DEPARTMENT OF ECOLOGY'S JUNE 5, 2008 RESPONSE TO COMMENTS:

**BURNT BRIDGE CREEK FECAL COLIFORM BACTERIA, DISSOLVED
OXYGEN, AND TEMPERATURE TOTAL MAXIMUM DAILY LOAD
QUALITY ASSURANCE PROJECT PLAN (MAY 2008 DRAFT)**

SUBJECT: Response to comments on the May 2008 draft Burnt Bridge Creek Fecal Coliform Bacteria, Dissolved Oxygen, and Temperature Total Maximum Daily Load Quality Assurance Project Plan

DATE: June 5, 2008

Burnt Bridge Creek Fecal Coliform Trend Analysis (1998 - 2007)

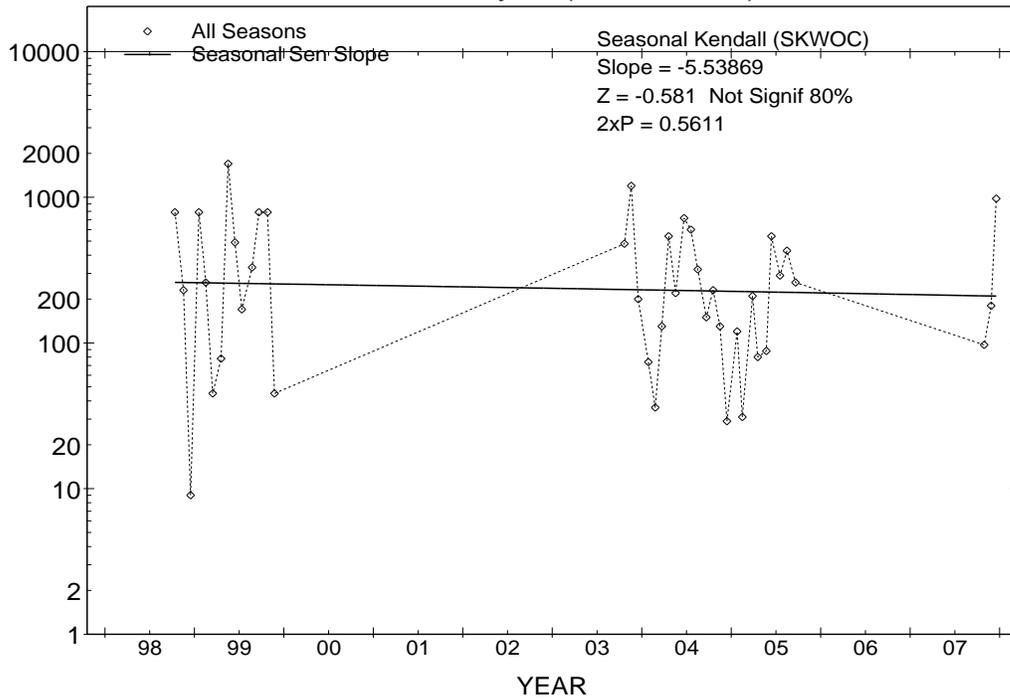
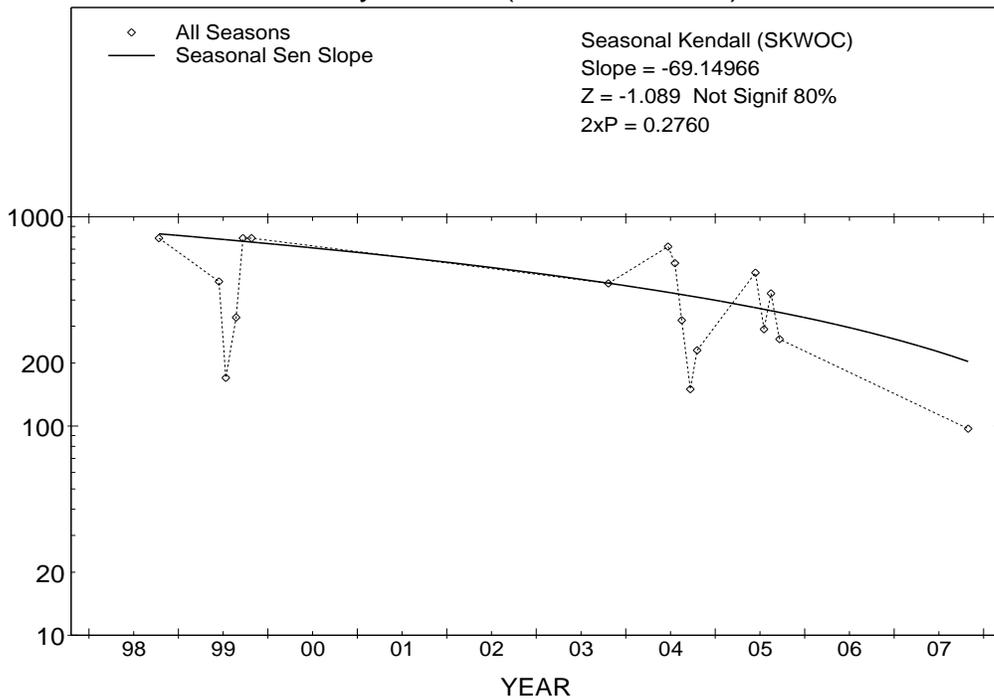
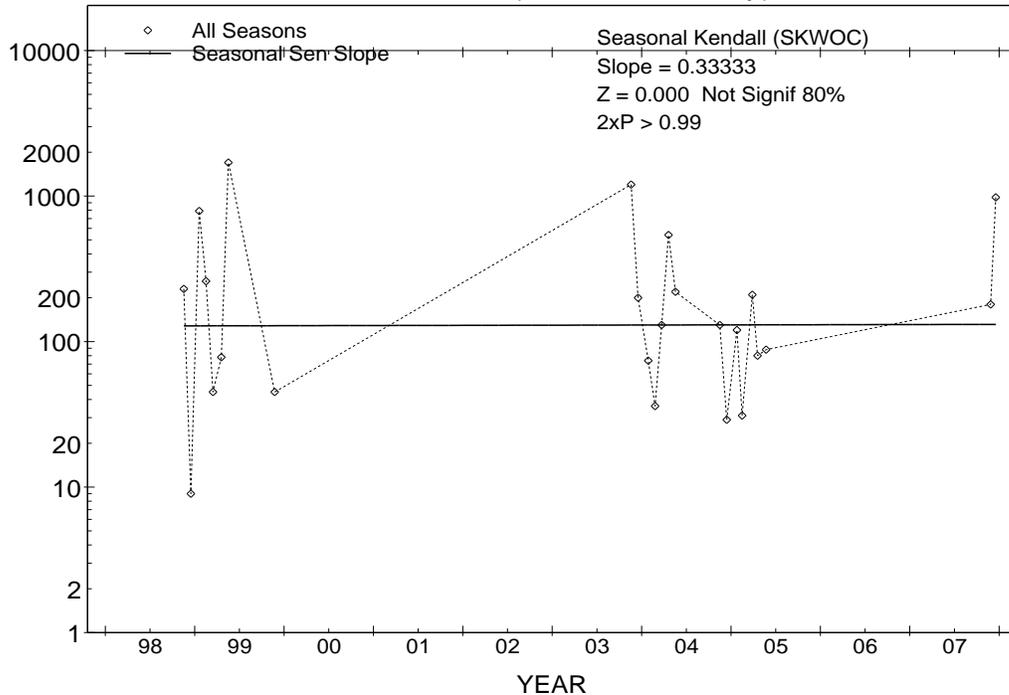
Comment 6: Page 33, Trend Analysis. “Is it possible to see the fecal coliform data used in this trend analysis?”

Response 6: The following graphs represent the trend analysis for the fecal coliform data collected at Alki Road between 1998–2007 by both the Department of Ecology and the City of Vancouver. Figures 1–3 show the fecal coliform trend for the entire data set, the dry season (June – October) and the wet season (November – May), respectively. The analysis found no significant trend over time. These fecal coliform graphs were not included in the draft QAPP because we only included data which showed significant trends.
